ADDRESS: 2201 PANAMA ST

Proposal: Construct fourth floor and roof deck

Review Requested: Review In Concept

2201 PANAMA ST
MEETING MINUTE OF AUGUST 2026
ARCHITECTURAL COMMITTEE

PROPOSED 22nd STREET SITE LINES

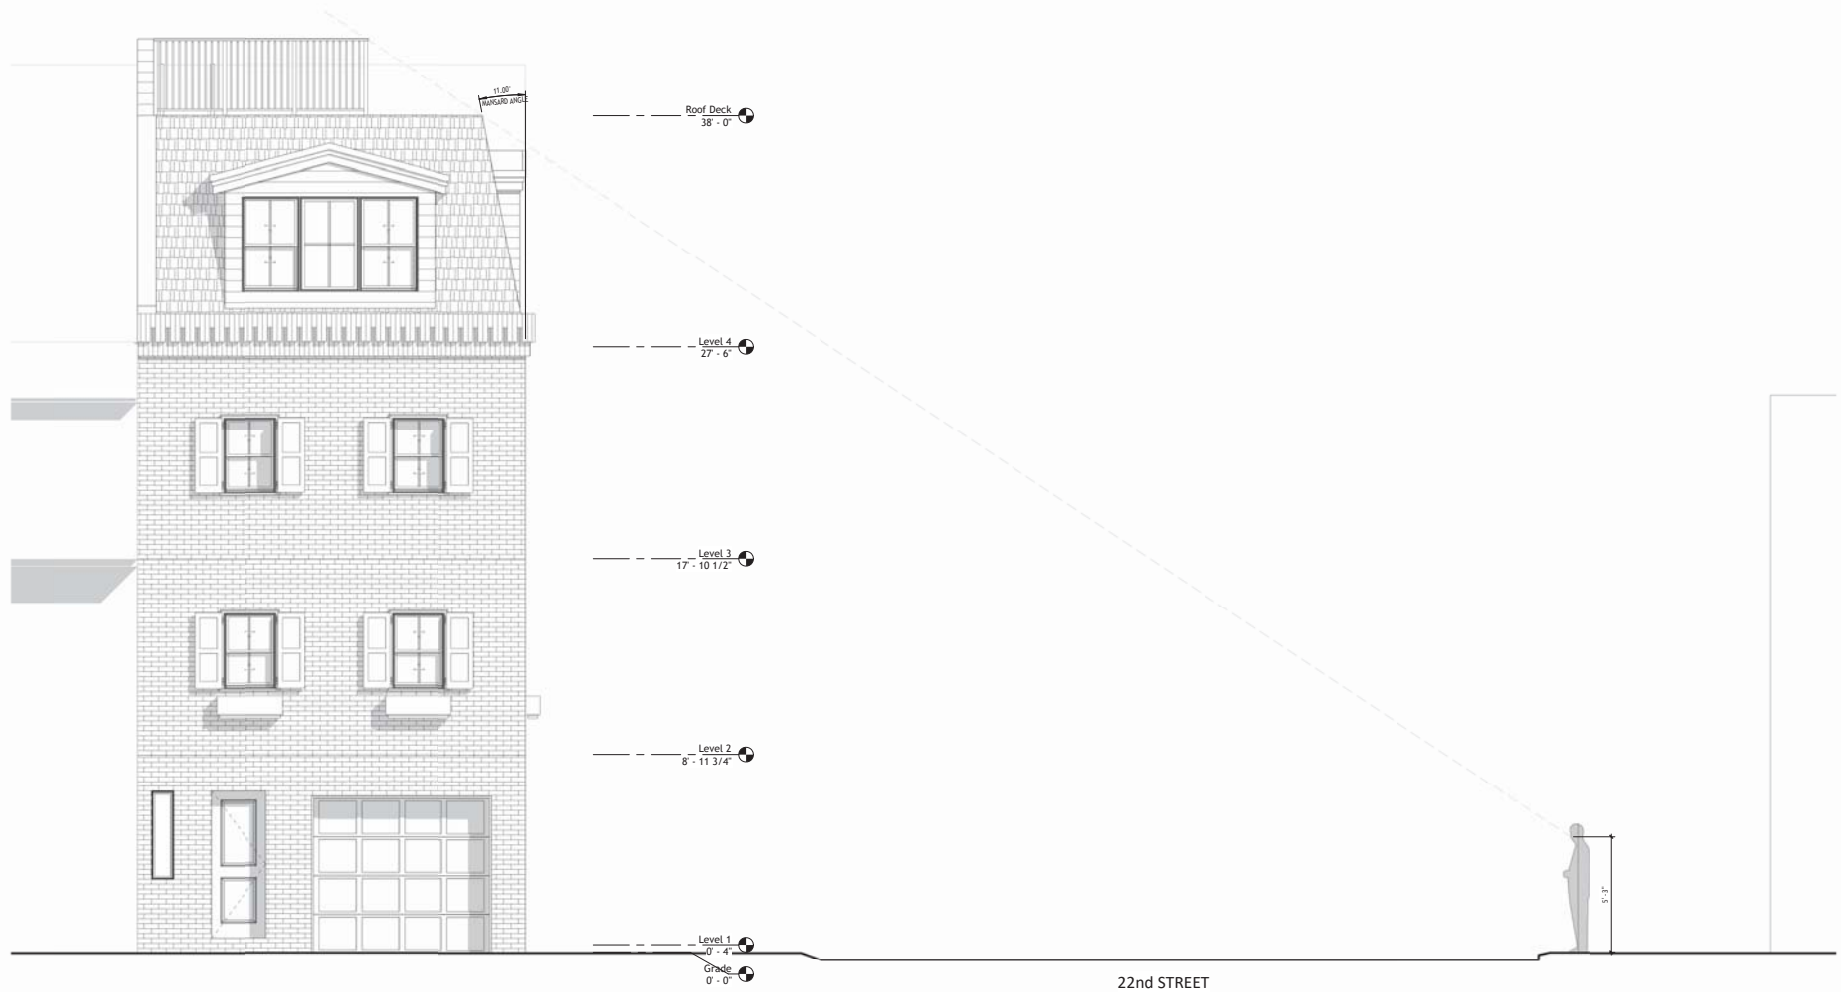
- o The Roofs Guideline does not apply to this application because the building in question is non-contributing; there are no character-defining features at the building. The roof deck railing is set back from the S. 22nd Street facade.

② Proposed Roof Deck
1/4" = 1'-0"

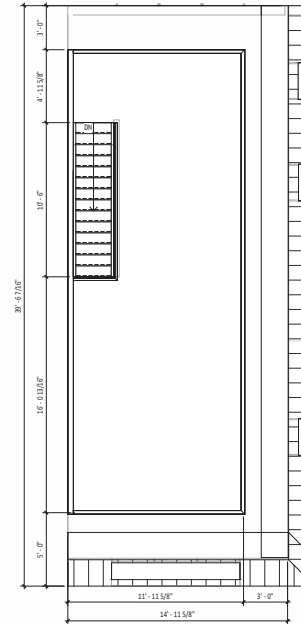
- Ms. Gutterman asked the applicant to respond to the staff's recommendation regarding the building's massing and roof deck.
 - Mr. Sidoti explained that the roof deck was designed to satisfy the zoning requirements. He expressed willingness to reduce the roof deck's size and visibility from the street.

- Mr. Detwiler noted the Rittenhouse Fidler Historic District is characterized by grey slate roofs, not black slate roofs.
- Ms. Gutterman urged that the architect reduce the length of the mansard roof to allow for construction of a rear third-story deck instead of one above the fourth story.

- Ms. Stein agreed that the roof deck should not be visible, which she noted is difficult to achieve on a corner property.
- Mr. McCoubrey also expressed support for the removal of the existing mansard roof, lightening the color of the new mansard roof, and reducing its height as much as possible.

③ Proposed Front Elevation
1/4" = 1'-0"

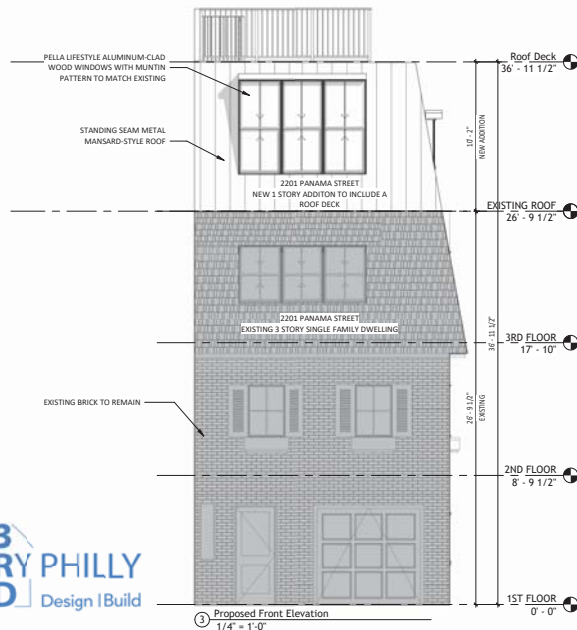
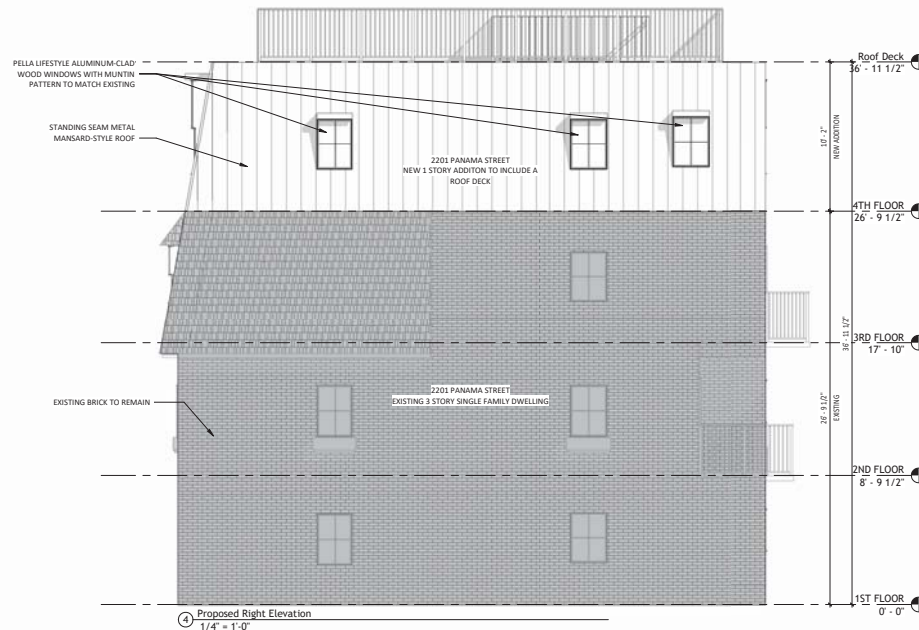
- Ms. Gutterman continued that the proposed fourth floor is too tall and the deck is too large, overwhelming the existing structure.
- Mr. McCoubrey asked about the floor-to-ceiling height of the proposed fourth floor.

- Mr. Sidoti said the exterior of the fourth story would be 10'-2" with a floor-to-ceiling height of 9'-6". He acknowledged that it is tall for a fourth story.

- Mr. Detwiler observed that the existing mansard roof extends below the floor line of the third story while the proposed fourth story mansard roof begins at the fourth floor level. He observed that these design decisions add unnecessary height of the proposed mansard roof.

- Ms. Stein expressed support for an addition but emphasized the importance of proper design details. She expressed support for the option that removes the existing mansard roof. She added that revising the color of the raised-seam mansard roof from black to grey would make the appearance less top heavy.
